Architect's Supplemental Instructions

Architect's ASI No: 035

Project:
Webster University
Interdisciplinary Science
Building

Discipline Code: 03 Electrical

**LEVEL 04 AREA A FLOOR
PLAN - ELECTRICAL &
AUXILIARY**

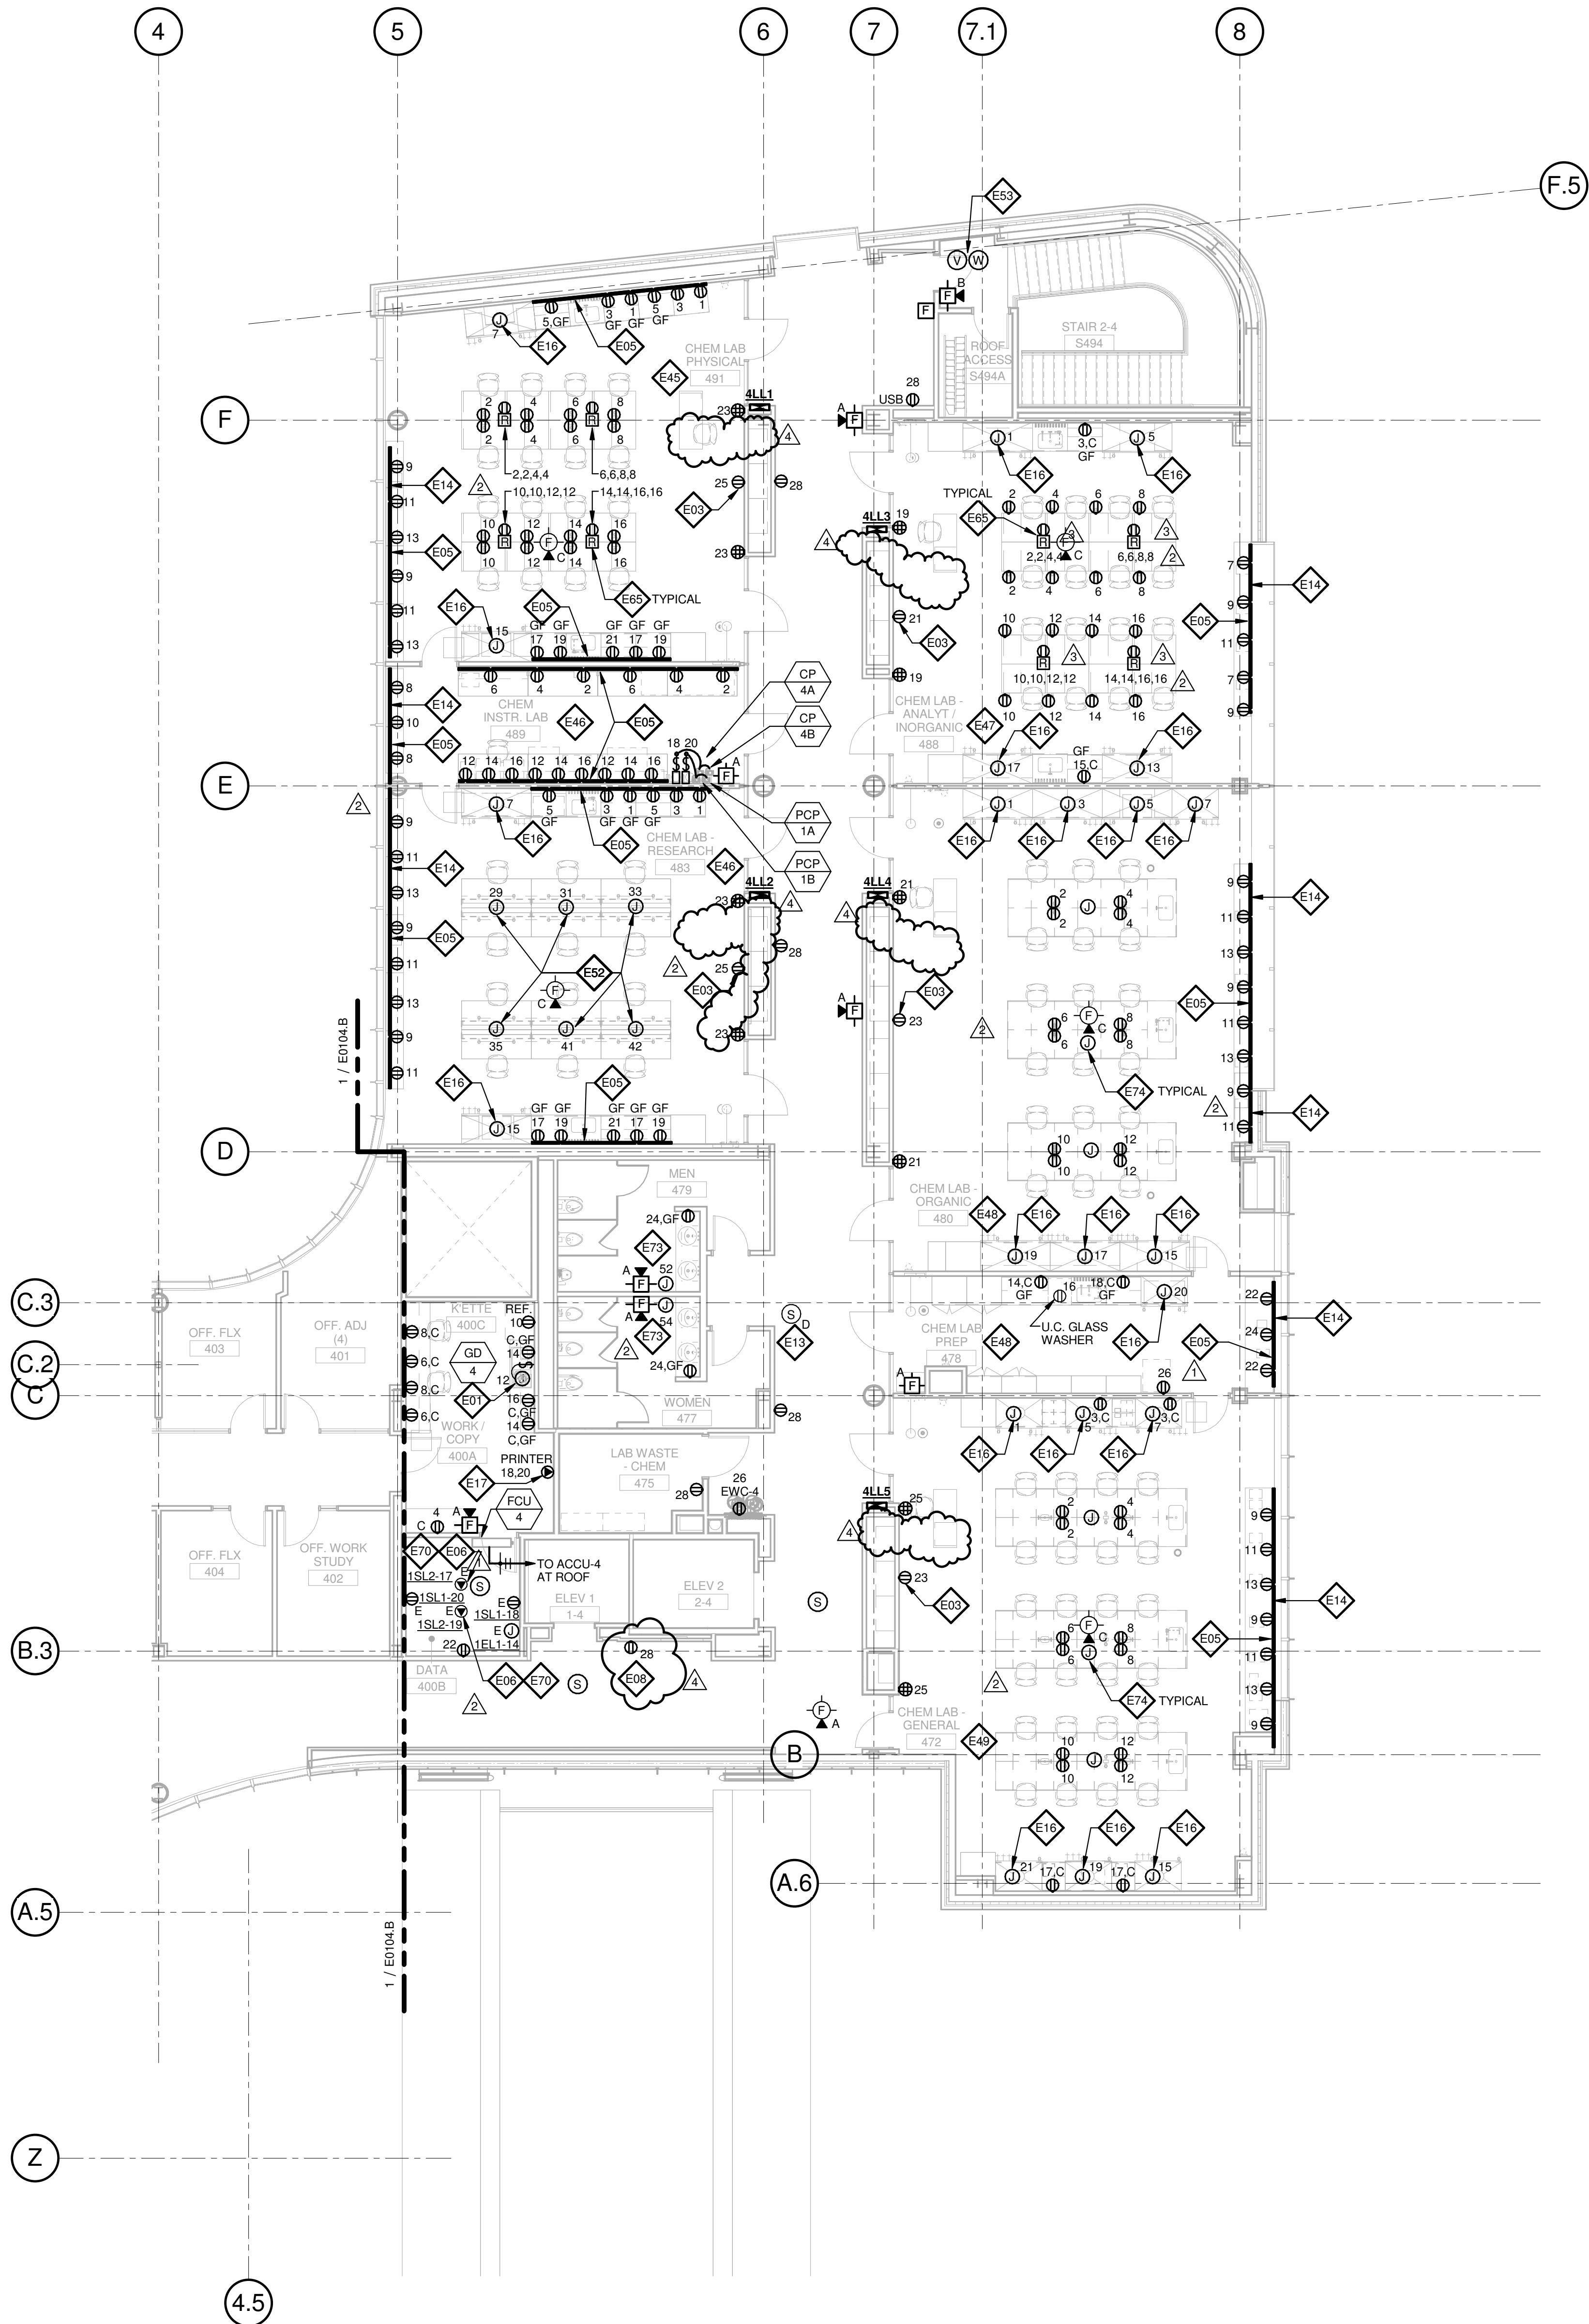
- Delete AV rack quadruplex receptacle and associated circuit in Lab 472.
- Delete AV rack quadruplex receptacle and associated circuit in Lab 483.
- Delete AV rack quadruplex receptacle and associated circuit in Lab 480.
- Delete AV rack quadruplex receptacle and associated circuit in Lab 488.
- Delete AV rack quadruplex receptacle and associated circuit in Lab 491.
- Add Keyed Note E08 to receptacle in Corridor C470.

**LEVEL 01 FLOOR PLAN -
AREA A**

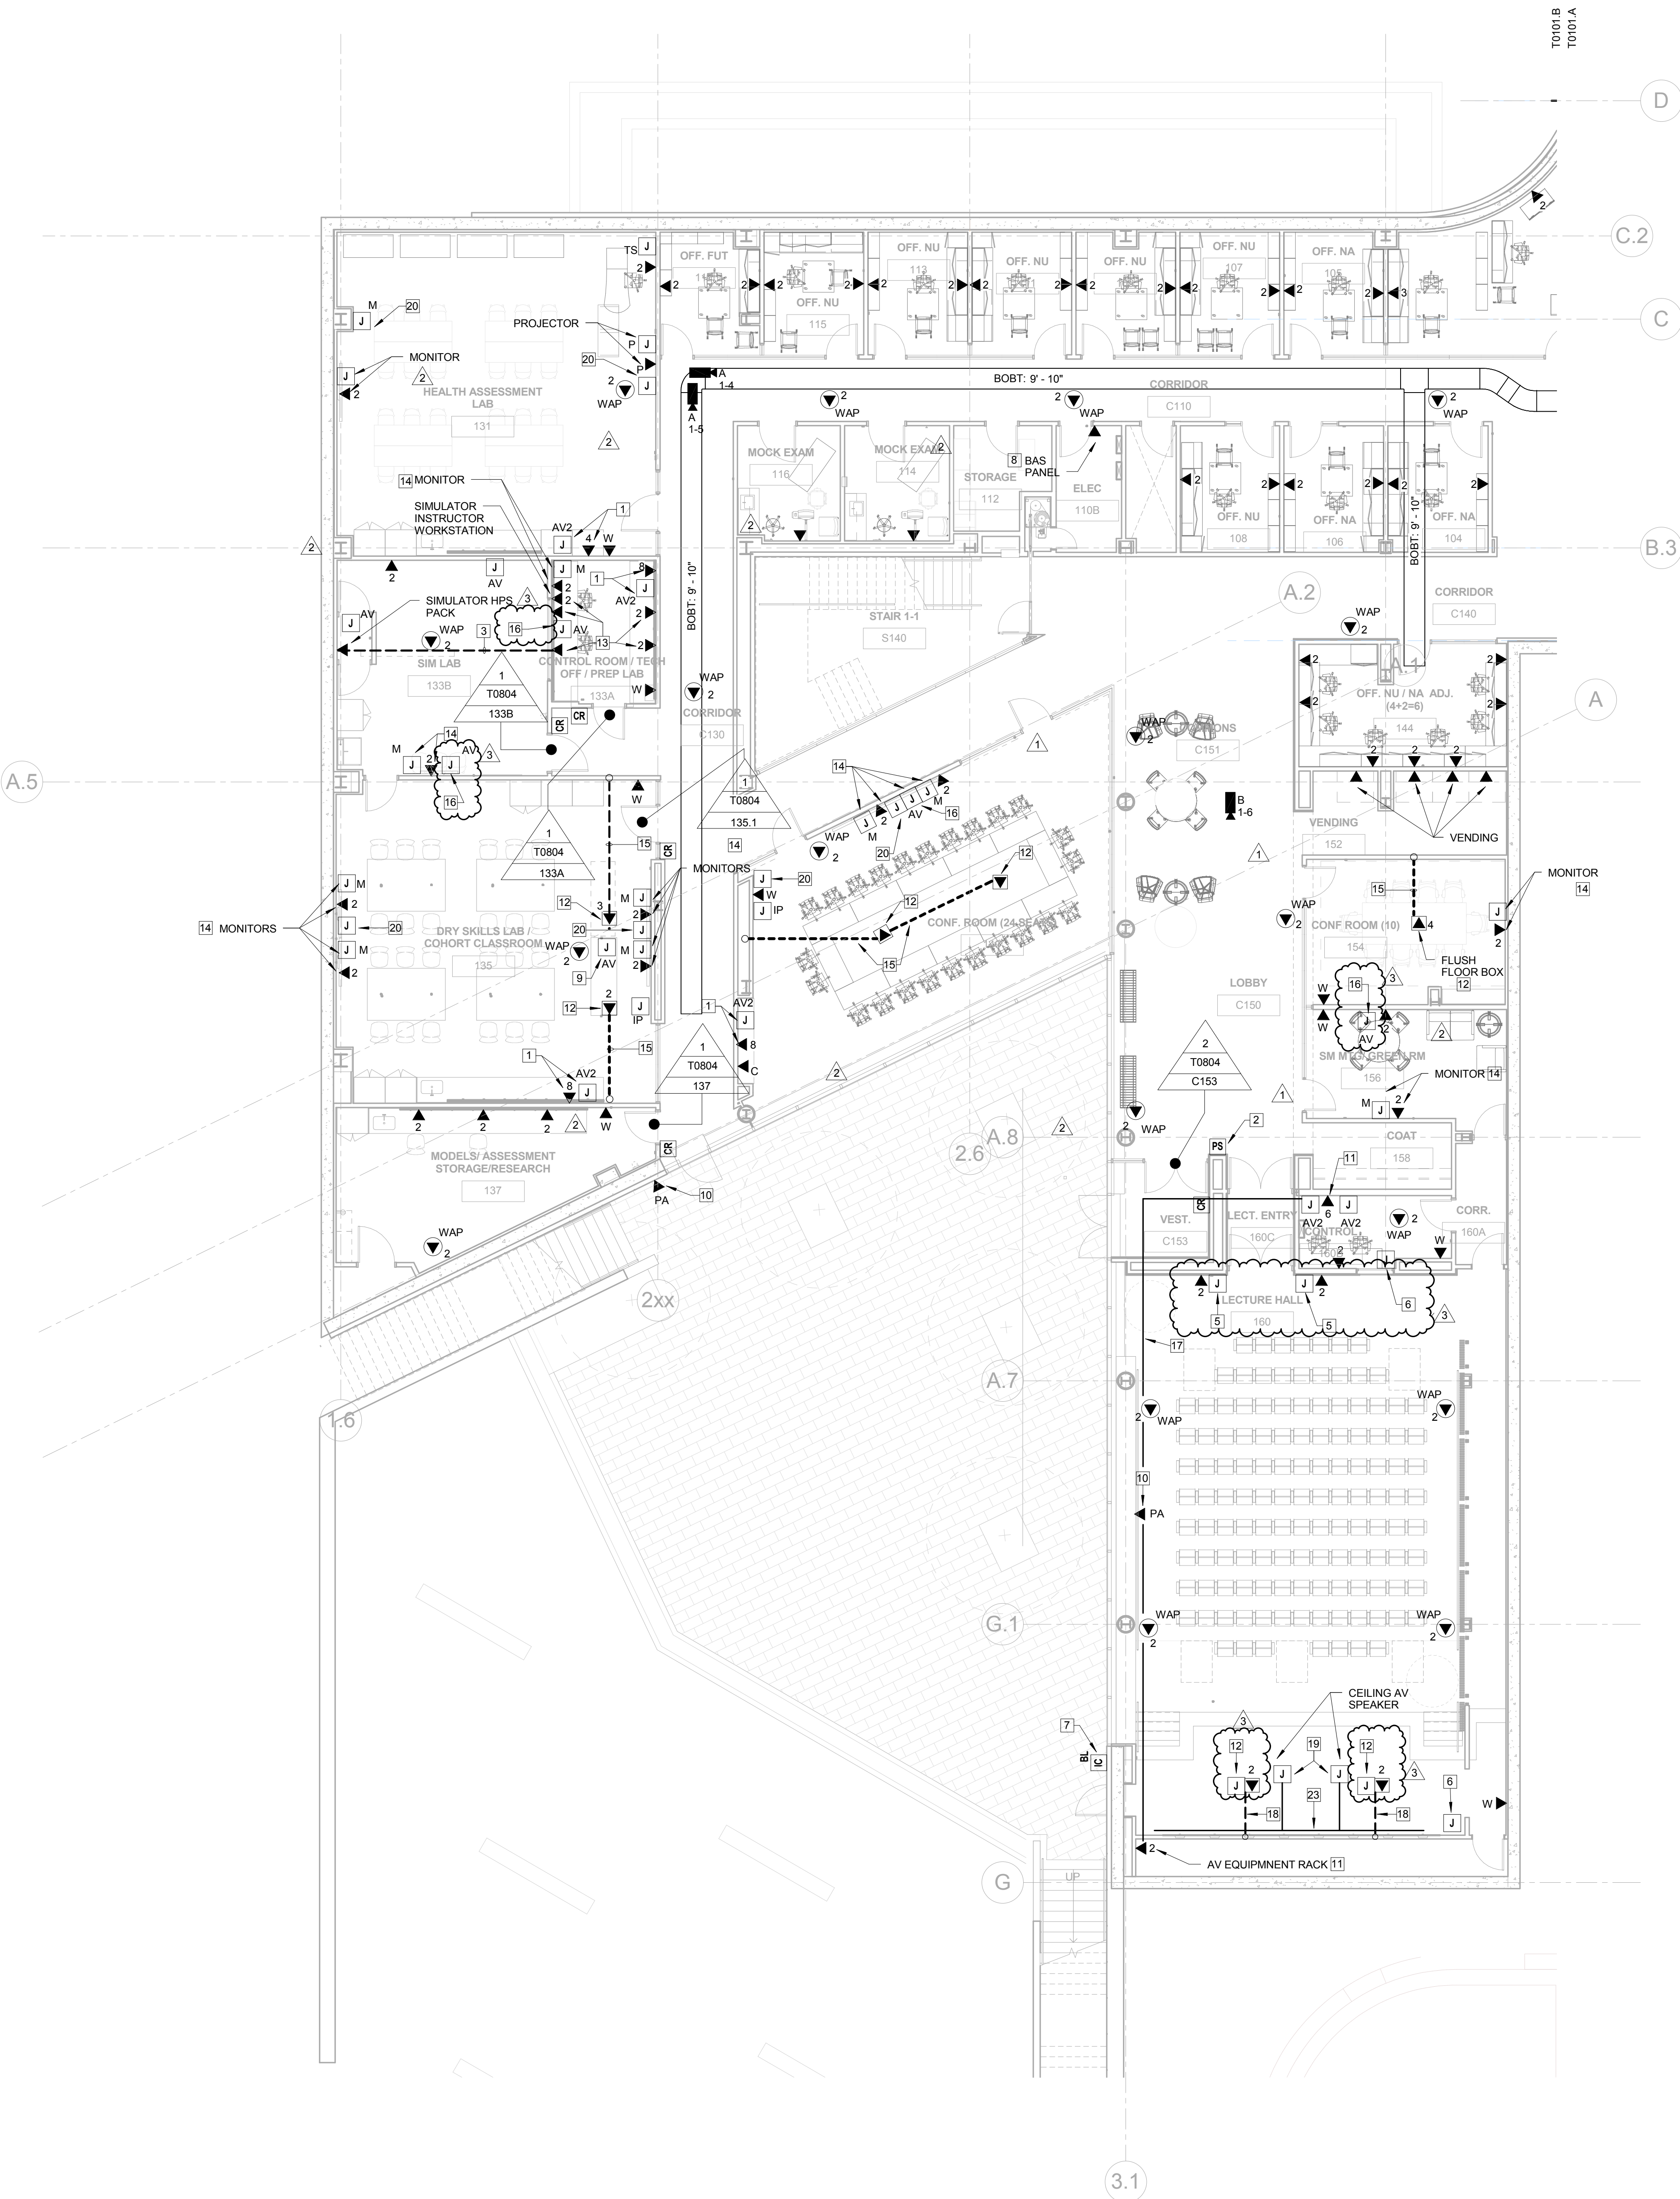
1. T0001 – SYMBOLS AND ABBREVIATIONS
 - A. Revised symbol description.
2. T0101.A – LEVEL 01 FLOOR PLAN – AREA A
 - A. Revised AV infrastructure in several locations.
3. T0101.B – LEVEL 01 FLOOR PLAN – AREA B
 - A. Revised AV infrastructure in several locations.
4. T0102.A – LEVEL 02 FLOOR PLAN – AREA A
 - A. Revised AV infrastructure in several locations.
5. T0102.B – LEVEL 02 FLOOR PLAN – AREA B
 - A. Revised Keyed Note.
6. T0103.A – LEVEL 03 FLOOR PLAN – AREA A
 - A. Revised AV infrastructure in several locations.
7. T0104.A – LEVEL 04 FLOOR PLAN – AREA A
 - A. Revised AV infrastructure in several locations.
